P-12062 S3496 34581

1		1 1
			NAME	DATE
(JINDAL)	$JINDAL\ ALUMINIUM\ LTD.$	DRAWN	PARVESH	15-12-2012
SYMBOL OF QUALITY	BANGALORE-560073 (INDIA)	CHECKED		
AN ISO 9001 COMPANY		APPROVED	S.S.GARG	15-01-2013
ALL DIMENSIONS ARE IN mm. ROUND OFF ALL SHARP CORNERS WITH 0.40 mm. TOLERANCES WILL BE AS PER BS:EN-755-9 UNLESS OTHERWISE SPECIFIED		SCALE		1:1
		AREA mm ²		193.779
		PERIMETER mm.		256.008
PARTY'S NAME	EUROCOUSTIC PRODUCTS LTD., MUMBAI	WEIGHT kg/	/m	0.523
		DRAWING	No. SE	CTION No.
PARTY'S DRAWING No.	AS PER DRAWING	P-12062 -		
		S3496	S349	96(ISSUE-4)
ALLOY & TEMPER	HE9 WP	34581 34		4581 <i>(</i>
DESCRIPTION	TOP & END TRIM PROFILE

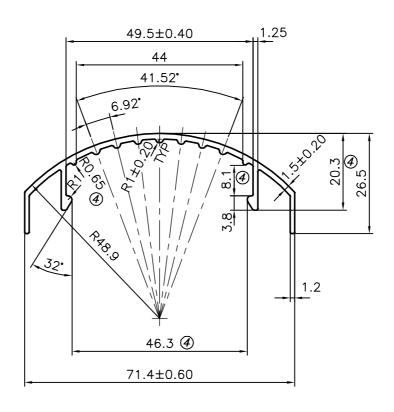
TOLERANCE ADDED ON R1.0±0.20 & 1.5±0.20

DIMENSION CHANGED FROM :-7.35 mm. TO 8.10 mm, 20.30 mm. TO 21.05 mm,

WEIGHT ALSO CHANGED FROM 0.531 kg/m TO 0.537 kg/m.

DIMENSION CHANGED FROM 21.05 mm. TO 20.3 mm., HENCE 8.1 mm. REVIEWED. DIMENSION RO.65 ADDED

WEIGHT ALSO CHANGED FROM 0.537 kg/m TO 0.523 kg/m.
